Re: Interpretation for SE 2001-D-022, Sugarland Hill Apartments, Housing for the Elderly
Tax Map 6-3 ((1)) 11: Building Layout and Fence Height

Re: Interpretation of Development Conditions Imposed in the Approval of Special Exception SE 2001-D-022

INTERPRETATION PLAN
Application No. SE 2001-D-002 Staff KS
Control No. SEI 0404 019
Approved: YES NO IN PART (circle one)
SEE RESPONSE LETTER DATED 7/15/04
of

Sheet Title
SITE PLAN
FAIRFAX CO.

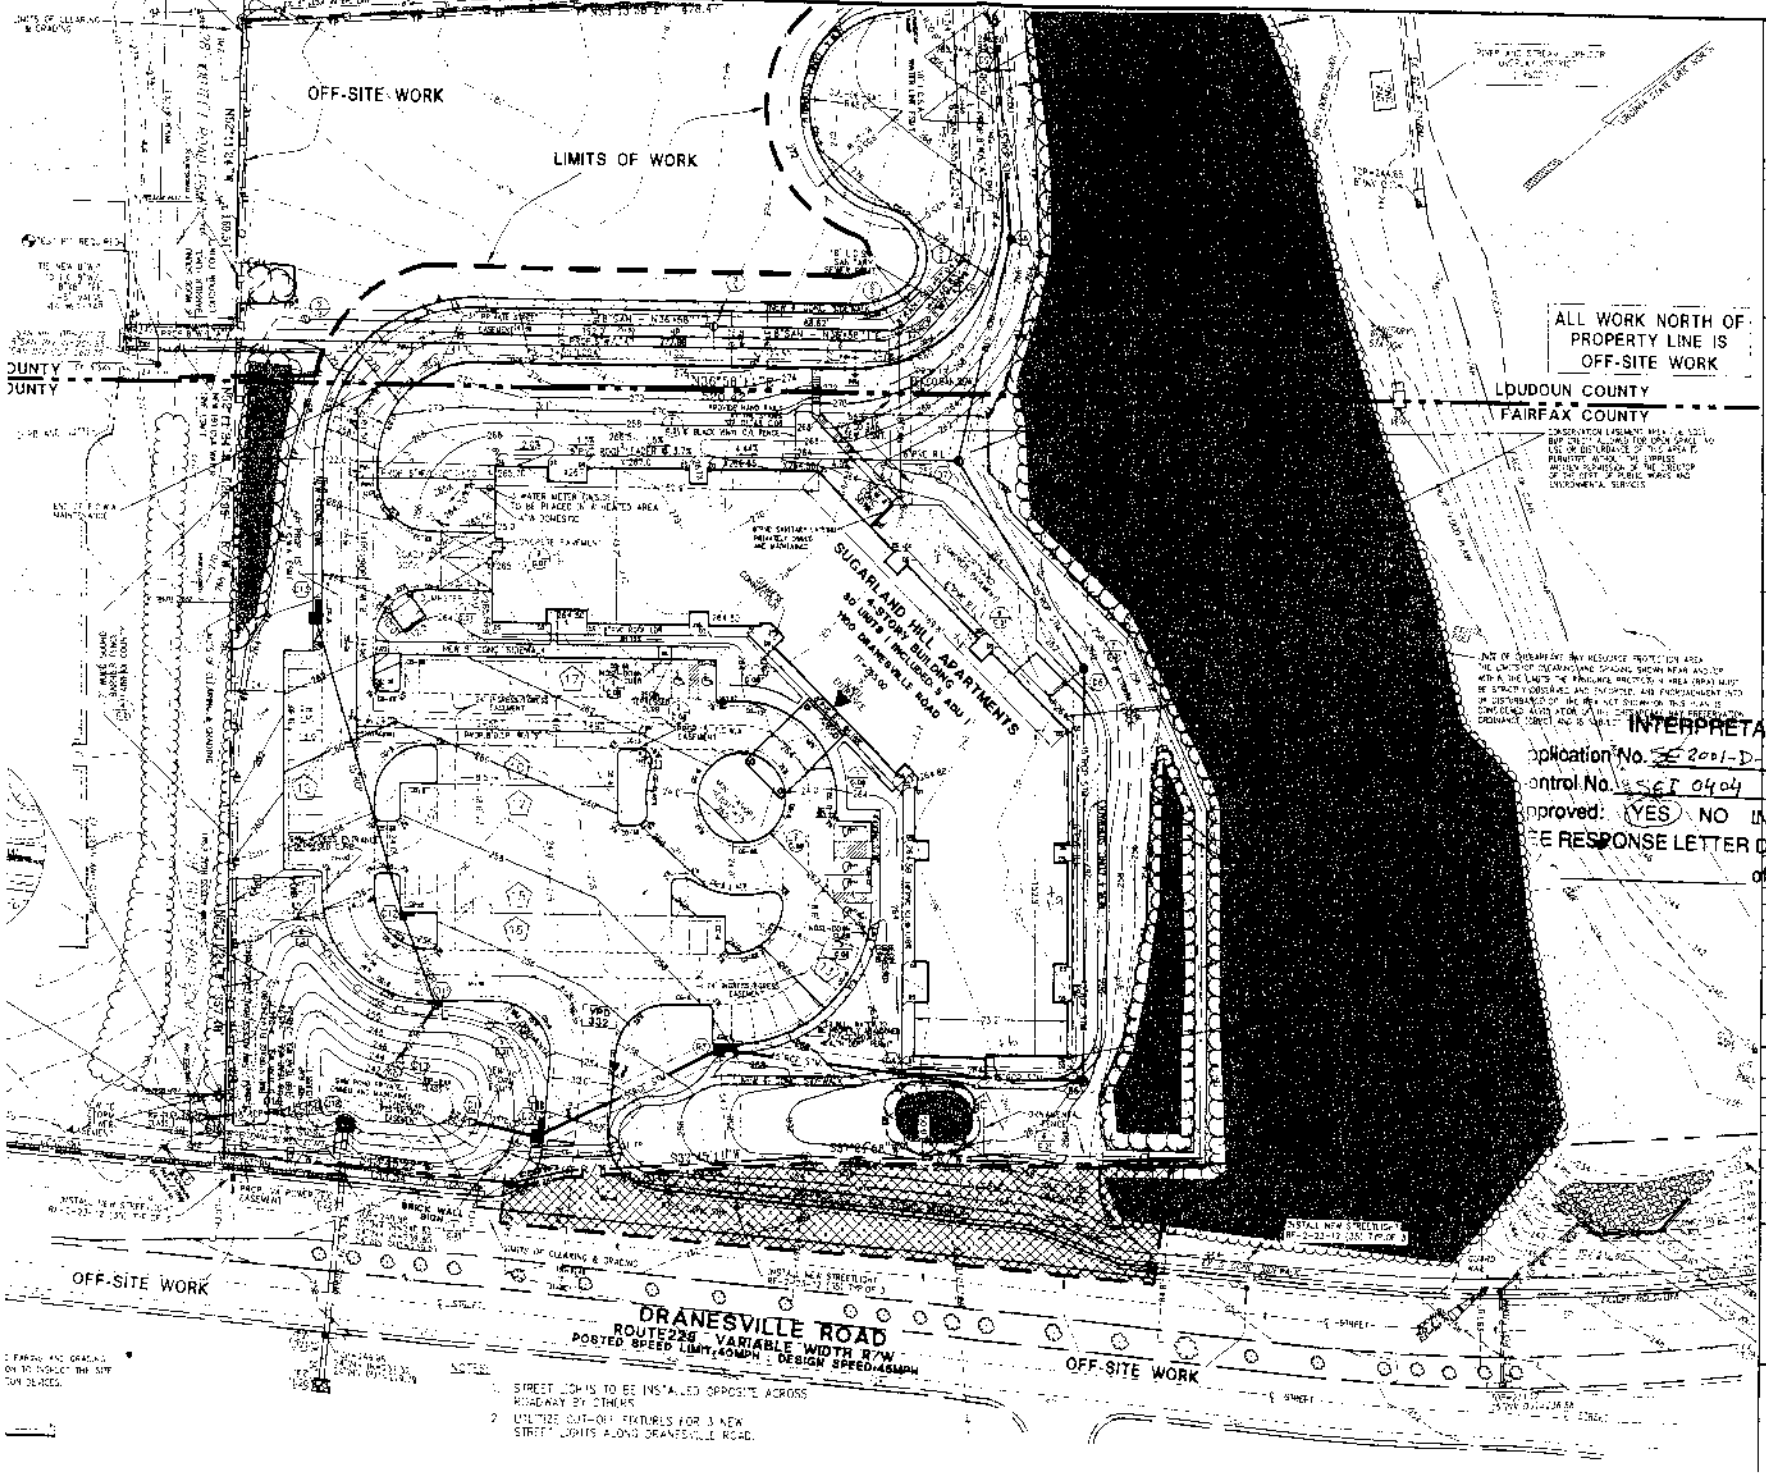
As I understand it you are proposing to increase the approved building setback by 2.1 feet on the south side (from 119.9 feet to 122.0 feet) and reduce the building setback by 6.8 feet on the northwest side (from 161.5 feet to 154.7 feet). The building width is proposed to increase by 4 feet; the building length would be increased by 0.8 feet. These changes are the result of final building design. No change in the approved number and type of units is proposed. You have stated that the final site plan indicates an increase in open space from 61.9% to 68% and no changes to buffering, parking or access to the site are proposed.

You also propose to increase the height of the fence to be located along the southern property line from six (6) feet to seven (7) feet to provide a transition to the 8 foot fence located on the Loudoun County portion of your site. Part of this project is located in Loudoun County.

It was a pleasure speaking with you this morning on the above referenced topic. As you might imagine, over the course of the interpretation process the site plan and final building design have continued to evolve. Attached is the most recent building configuration for the property as prepared by the project architects and engineers. Please note that the width of the building is approximately two (2') feet greater than that shown on the previous exhibit (now 73.2 feet). Consistent with all previous assumptions, the density of the project has not increased and remains at 80 units total, inclusive of five (5) affordable dwelling units. Similarly, the amount of open space remains in excess of that shown on the approved Special Exception Plan. The most current site design reflects slightly more than 68% total open space. This remains in excess of the 61.9% referenced on the approved Special Exception Plan.

It is my determination that the proposed increase in fence height from 6 feet to 7 feet along the southern property line and minor modifications to the building footprint and setbacks would be in substantial conformance with the SE Plat and the development conditions. This determination has been coordinated with the Zoning Administration Division and has made in my capacity as the duly authorized agent of the Zoning Administrator.
